**APPLICATION FOR PERMISSION UNDER SECTION 16 TOWN PLANNING
APPLICATION FOR PROPOSED TEMPORARY PRIVATE CLUB FOR A PERIOD OF
FIVE YEARS AT LOTS 229 S.B SS.1 AND 227 RP IN D.D. 41, SHA TAU KOK, NEW
TERRITORIES**

Town Planning Application No. A/NE-STK/34 – Further Information (2)

Geotechnical planning review report

SITE PLAN FOR THE EXISTING SOILFILL AND CONCRETE BLOCK TO BE REMOVAL

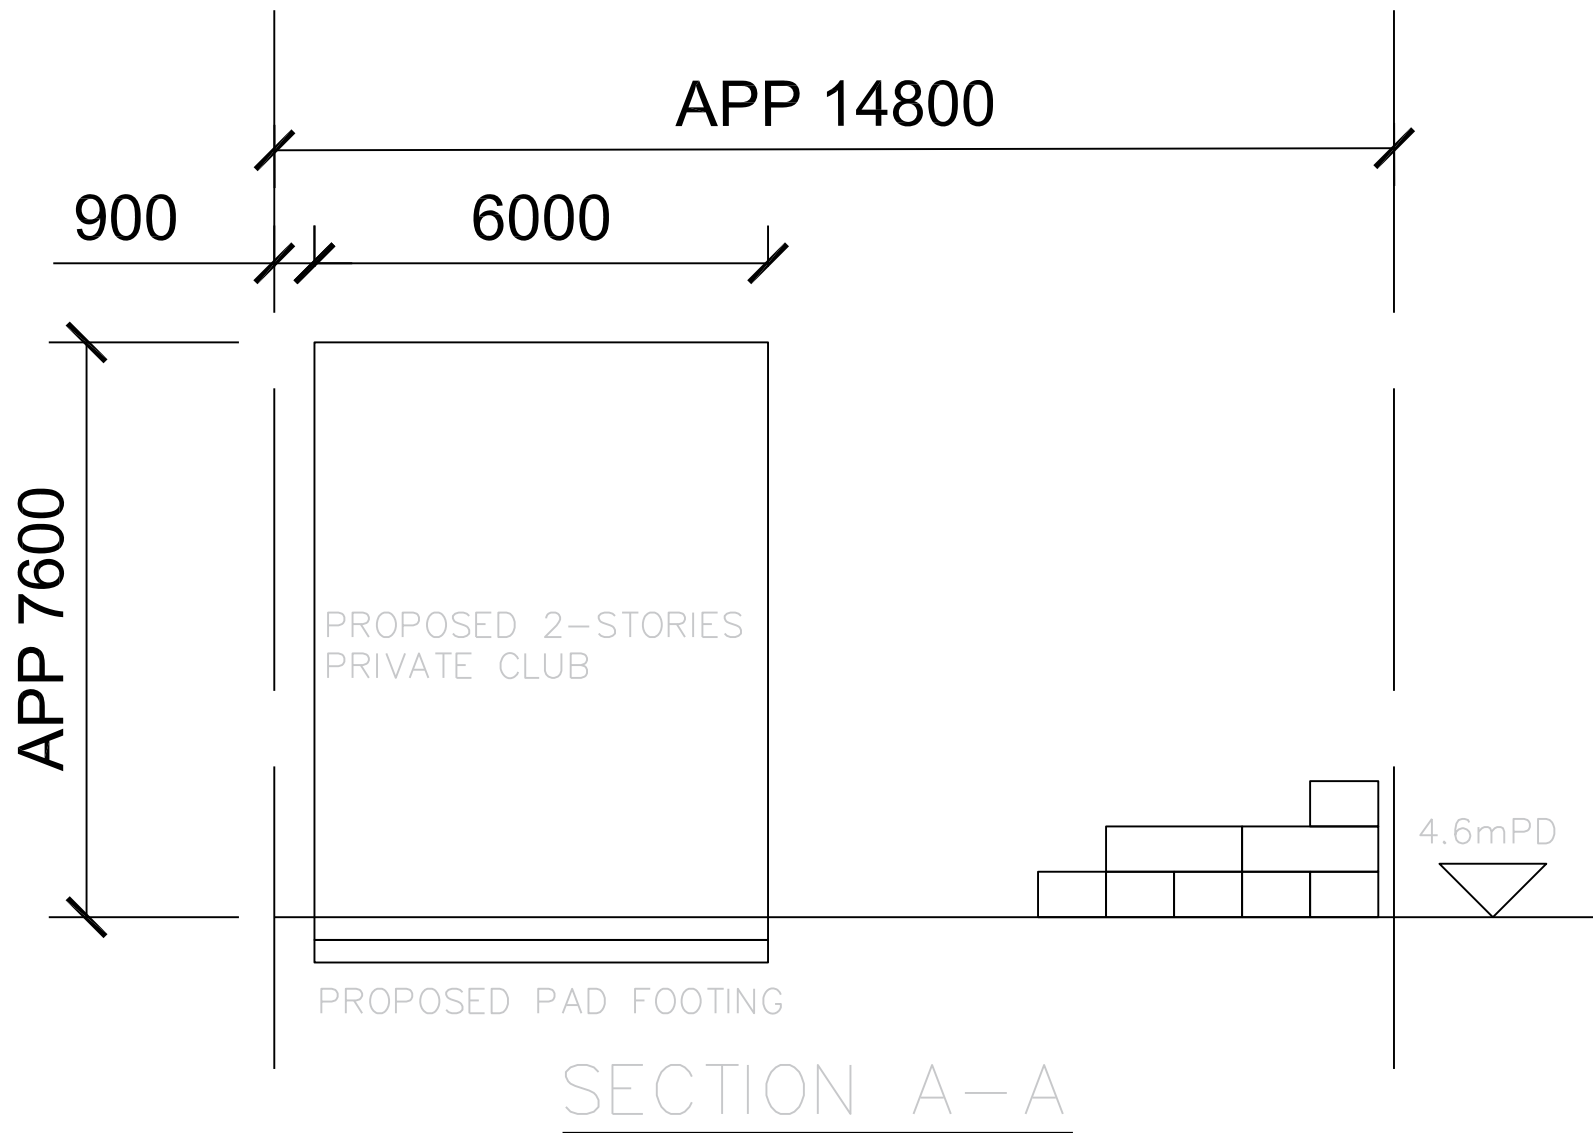
Departmental Comments (Email from Planning Department dated 29.06.2026)	
Departmental Comments	Response
<u>GEO,CEDD</u>	
based on the records of GEO, CEDD, within the application site of the planning application, GEO, CEDD received an Integrated Call Centre (ICC) referral (ICC Case No. 3-9002402973) regarding suspected unauthorised slope works (USW) which involve a filling platform and a concrete block retaining wall formed at Lots 218, 219, 220, 221, 222, 223, 224, 227 RP, 228, 229 S.B ss.1, 230 S.A, 230 S.B RP, 231, 232 S.B ss.2 RP and 2083 in D.D. 41; and	Noted.
since the application site will affect and be affected by the USW and in order to ensure the safety of future users, the planning application is not supported at this stage until the necessary remedial/reinstatement actions are completed to the satisfaction of the relevant government departments.	Noted. Please refer to Attachment 1: Geotechnical Planning Review Report for the remedial/reinstatement actions.

Since the existing level inside our lot haven't change, there only have some concrete block and soil backfill(800mm THK.) , will remove the concrete block and soil backfill inside lot boundary.
